1 INTRODUCTION

- 1.1.1 Prime Transport Planning Ltd (Prime) have been provided with comments from Phil Palmer (Highway Development Control Engineer) at Wrexham County Borough Council (WCBC) dated 29th January 2019. These comments were made in relation to the Transport Statement (TS) prepared in support of a full planning application (EP/DC/P/2018/1086) for a proposed commercial development located off Clywedog Road North on Wrexham Industrial Estate (WIE). The development has an access point onto Clywedog Road North. The parcel of land comprises B1/B2 usage of up to 35,198 sqft.
- 1.1.2 This document has been produced in response to the above-mentioned comments and intends to provide, where possible, the information and clarification requested by WCBC.
- 1.1.3 WCBC's comments are provided in *red italics* below with Primes response in black standard font.

9 Hurricane Court Liverpool International Business Park Estuary Boulevard Liverpool L24 8RL www.primetp.co.uk 0151 728 1860	C	08.04.19	AM	UPDATED TO SITE LAYOUT P8	Project	WREXHAM INDUSTRIAL ESTATE - SITE 4	Drawn by	Issue date
	B	20.11.18	VB	UPDATED TO SITE LAYOUT P4			AM	08 APR 2019
	A	07.11.18	VB	UPDATED WITH HIGHWAY BOUNDARY

P18044-002C

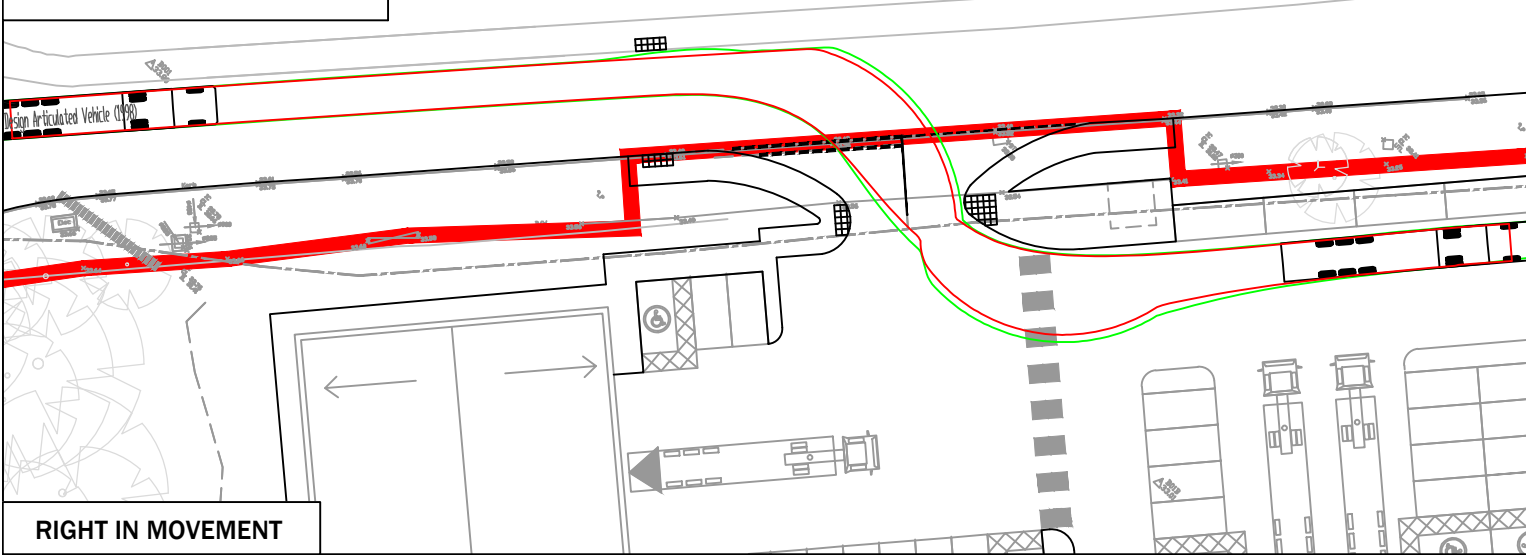
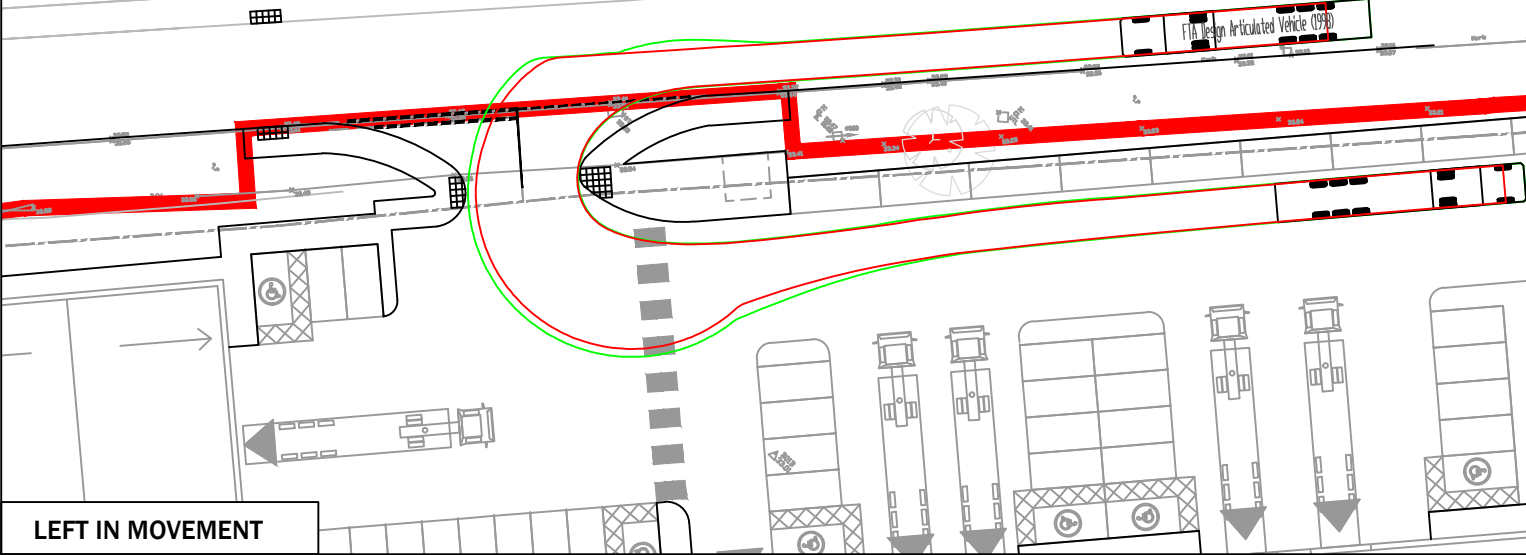
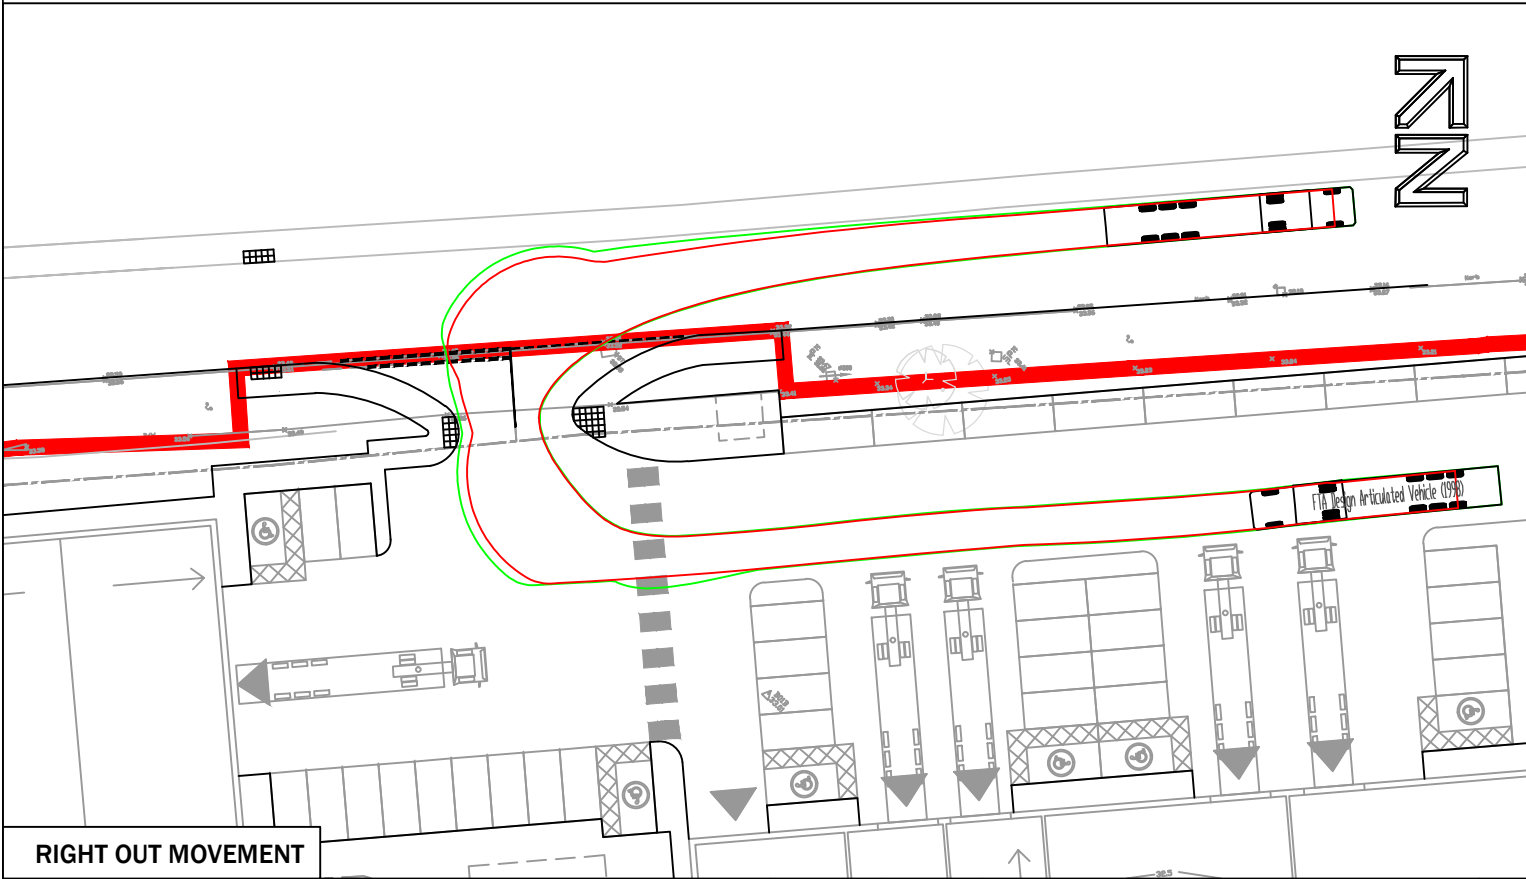
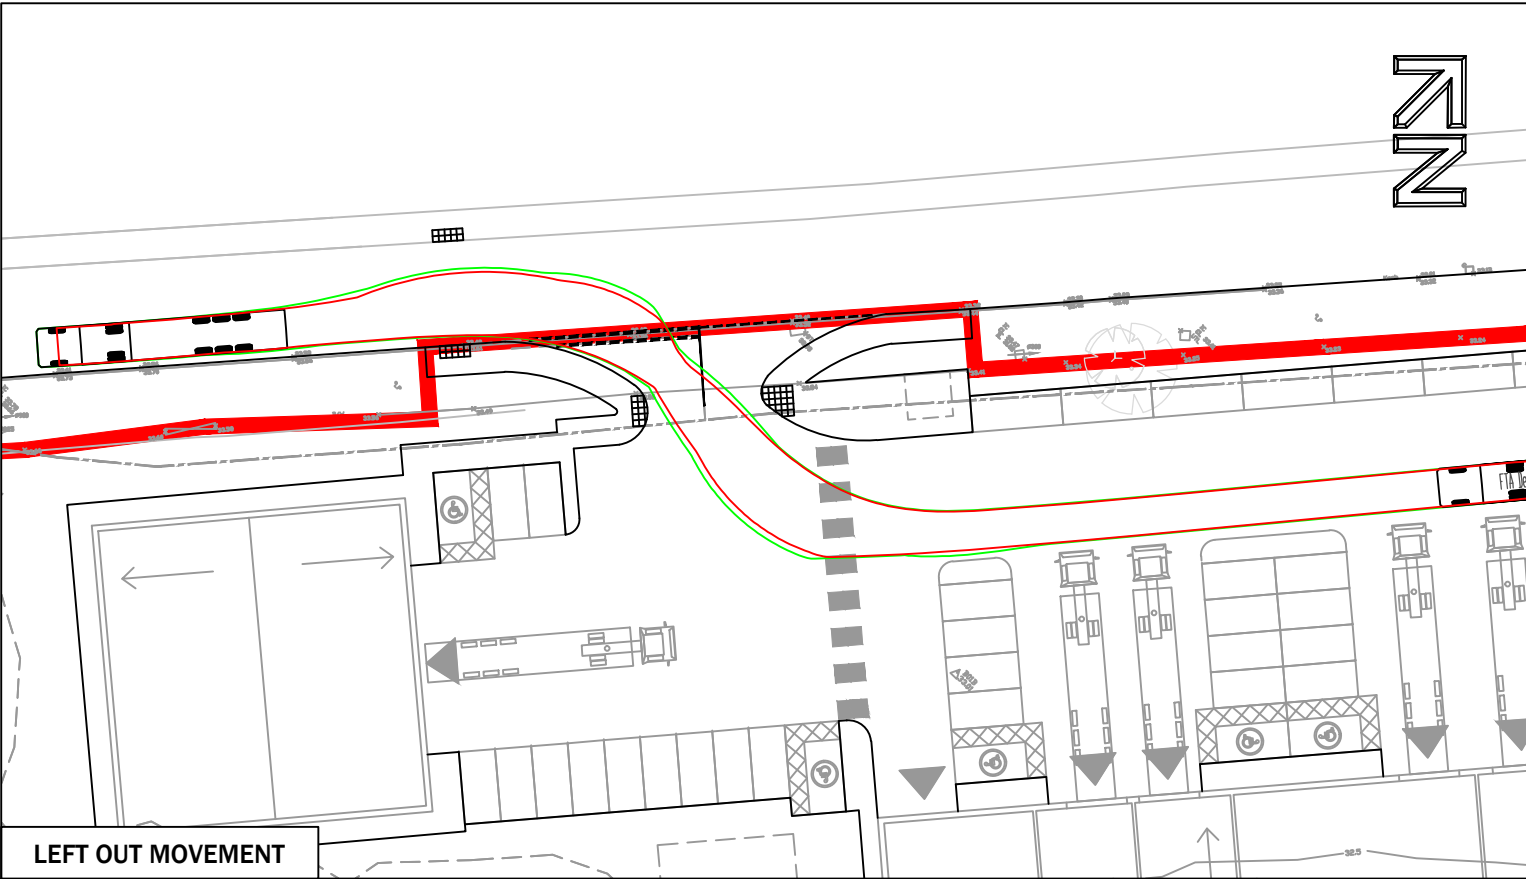
- 2.1.1 *Point 1: the proposed 13.25m wide access would be considered unsuitable to serve the proposed development site. The proposed access would require pedestrians to walk across a 13.25m wide access which is considered unacceptable.*

- 2.1.2 Amended access drawing **P18044-001C**, provided within **Appendix I** of this response, details the reduced access carriageway width to the site. The access can be seen to be 7.5m in width with 15m radii. **Drawing P18044-002C** contained within **Appendix I** demonstrates that a 16.5m articulated lorry can still access and egress the site via this amended access point.

P18044-003A

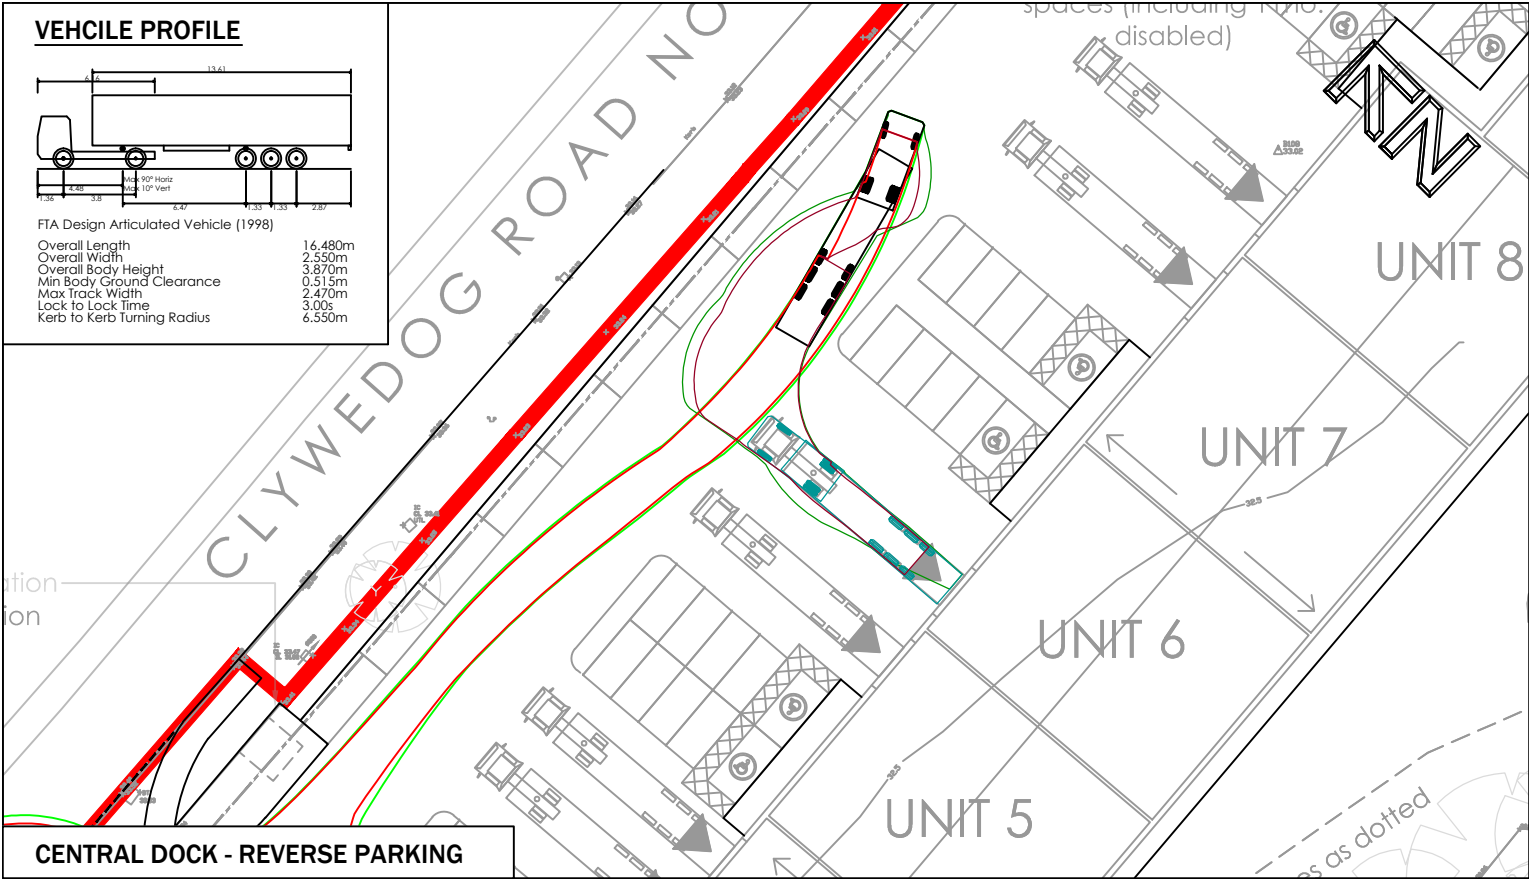
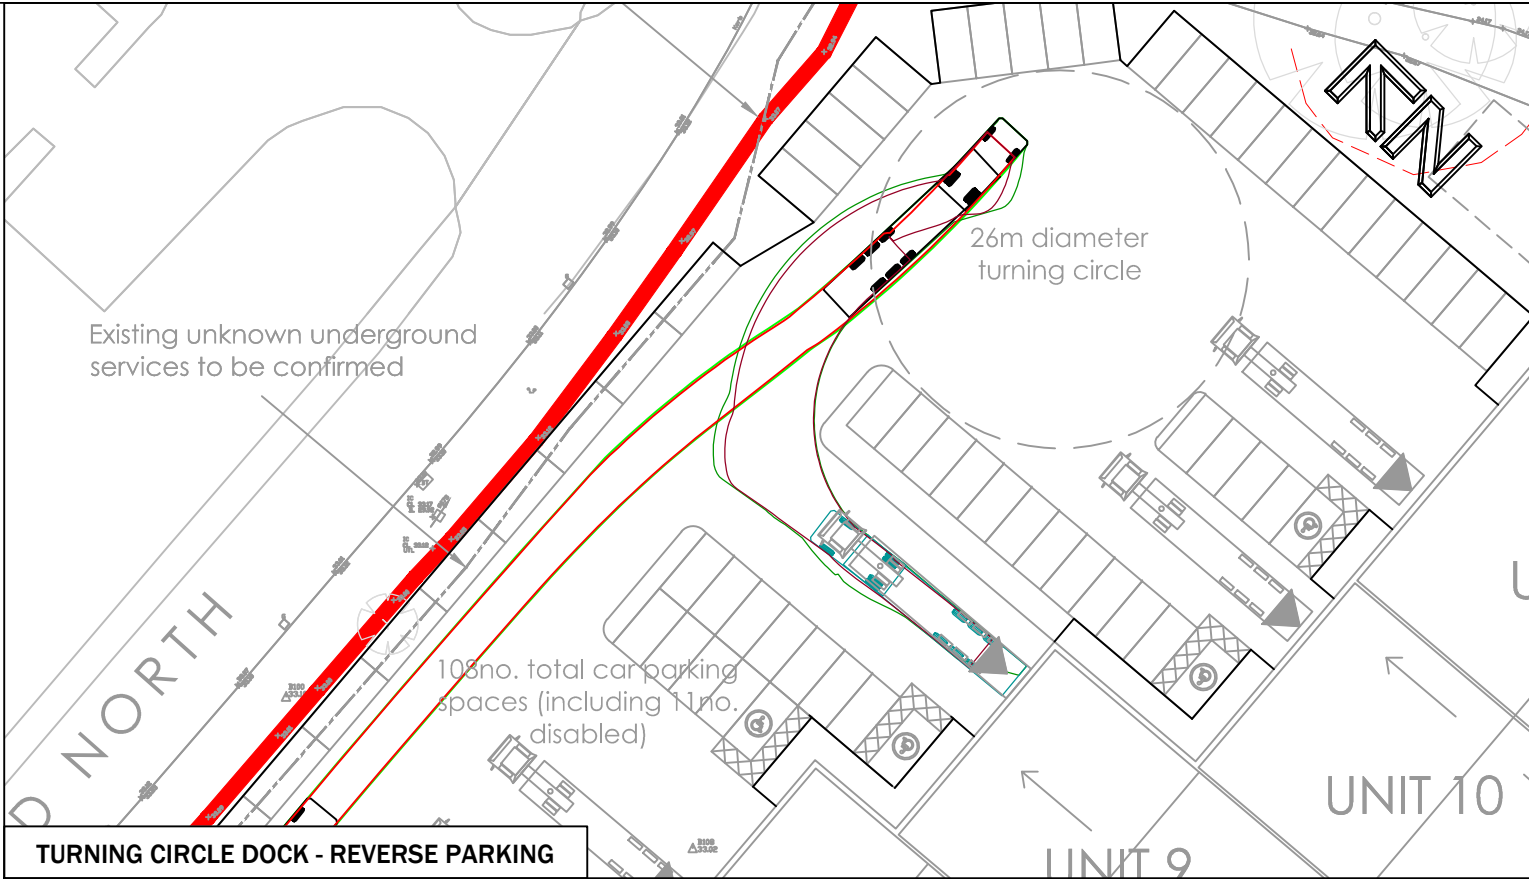
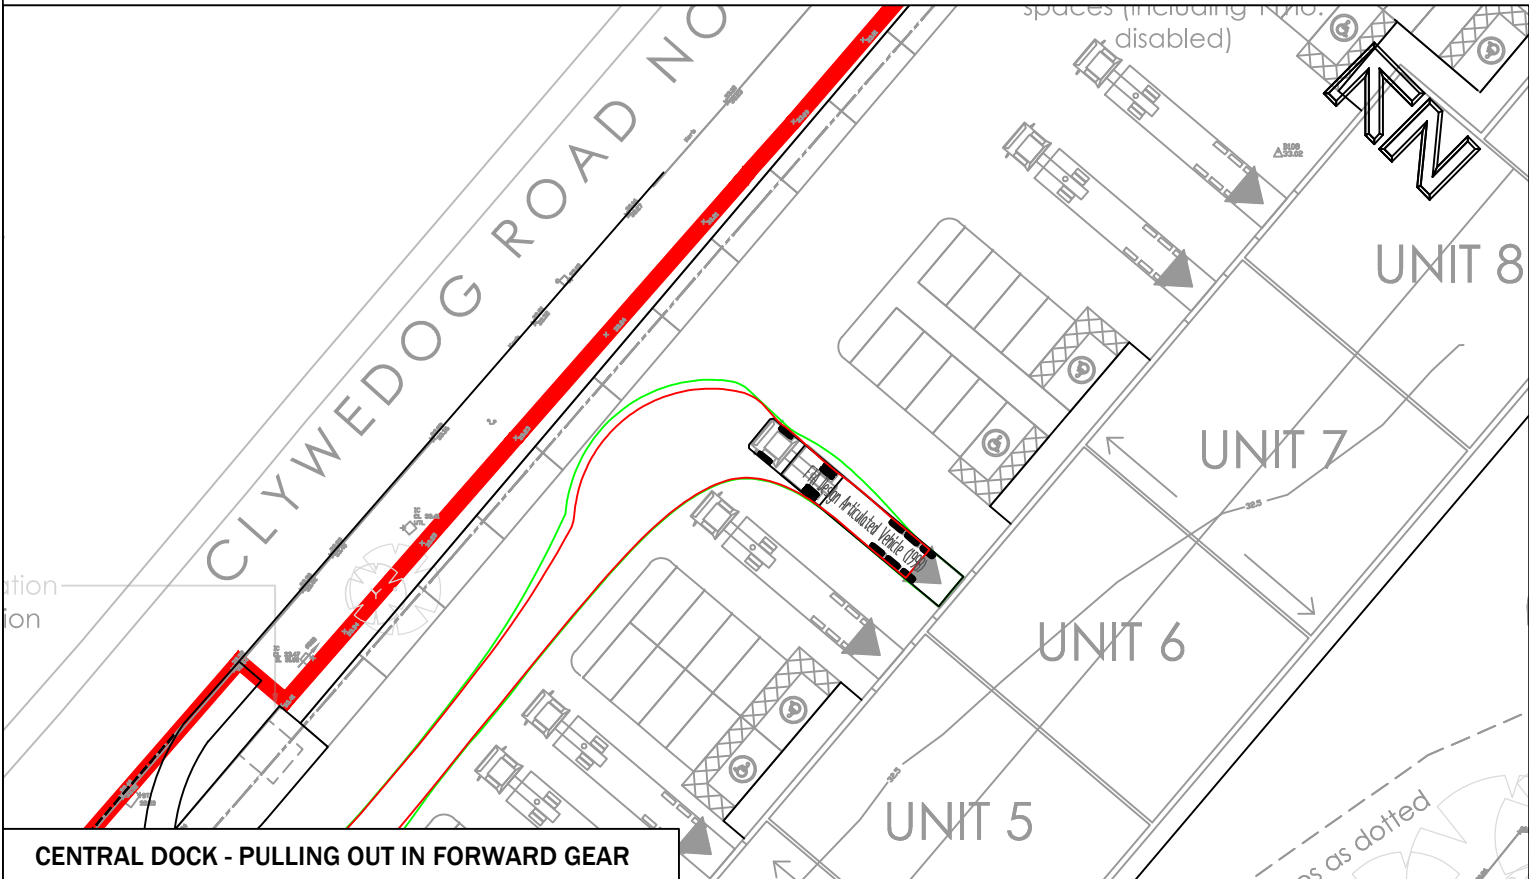
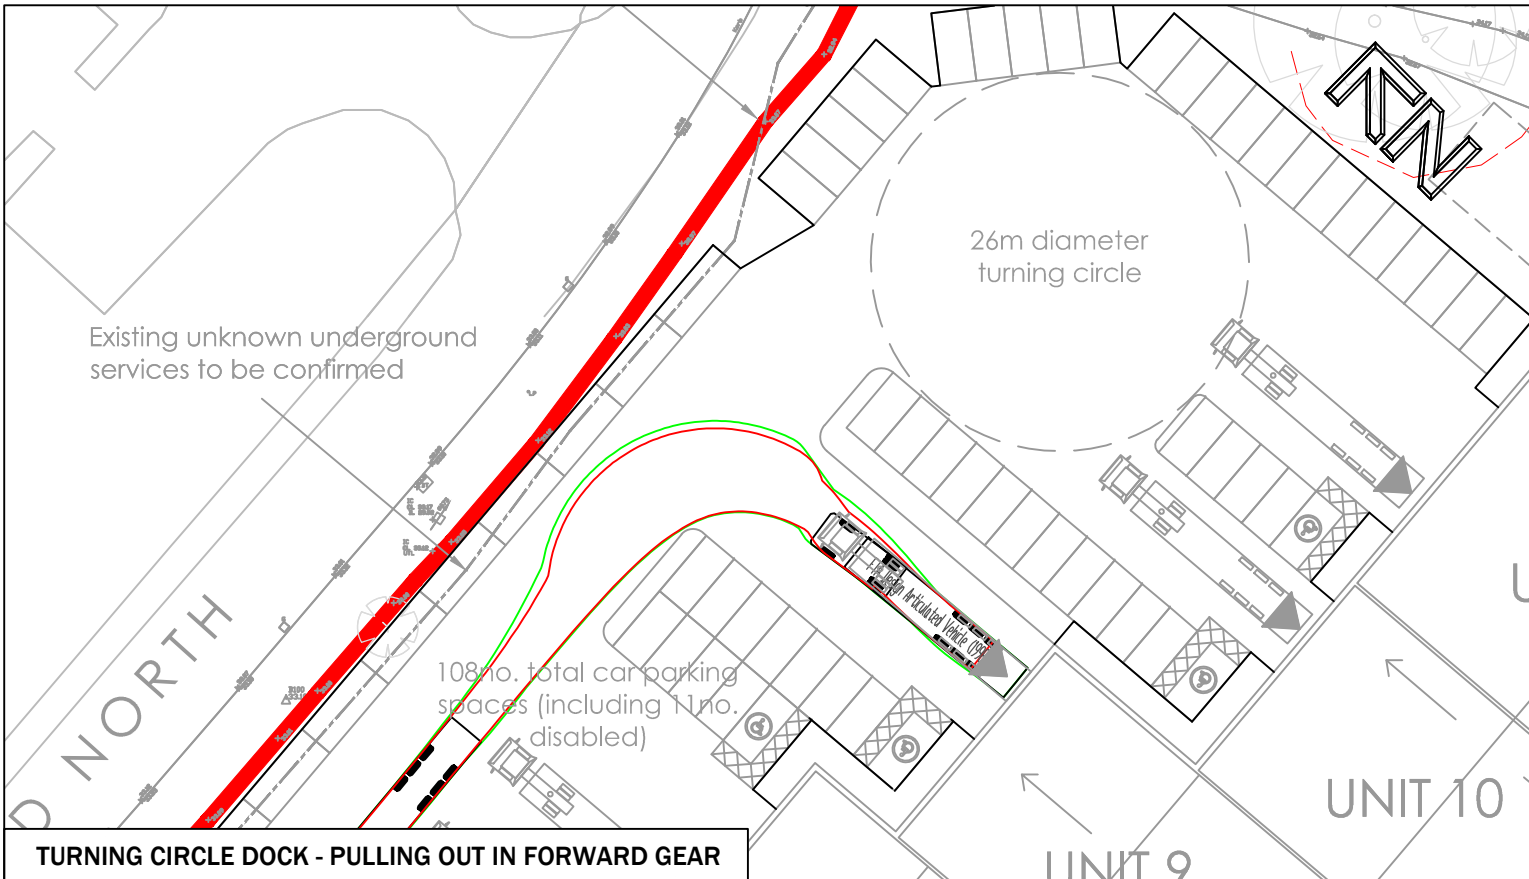
- 2.1.5 *Point 2 – There would appear to be a turning facility located directly behind the access to allow 16.5m HGVs to turn. This arrangement is considered unacceptable and has the potential for conflict of vehicle movements entering/exiting the site.*

- 2.1.6 The turning facility located directly behind the access has been removed in line with WCBC comments, vehicles turning within the site can still be accommodated within the turning circle shown toward the eastern part of this site, as seen with **Drawing P18044-003A** contained within **Appendix**
